Town of Windham

September 18, 2025

To: Amanda Lessard, Senior Planner
Steve Puleo, Planning Director
From: Mark Arienti, P.E. Town Engineer
Re: Smith Cemetery Site Plan Application Comment Response

Completeness Review (responses in red type)

Attachment A. Lighting Fixture Details

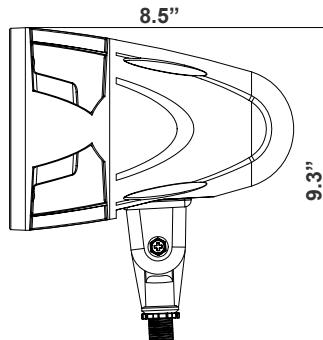
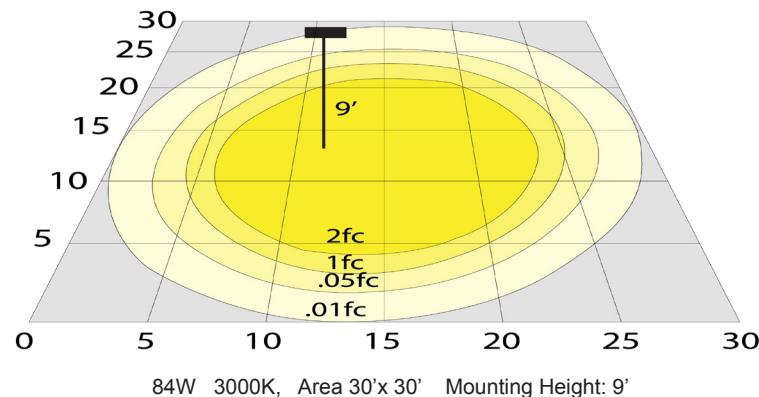
- §120-811B(1)(c) Written Information.
 - [12] Detail sheets of proposed light fixtures. *Any exterior lighting proposed on the shed and lighting for flag pole. The only proposed lighting is for the flagpole (see attached example light fixtures in Attachment A). Only interior lighting is proposed for the maintenance shed. A proposed lighting fixture for the flagpole is attached. We are also considering solar-powered lighting, which would be attached to the pole and shine upwards.*
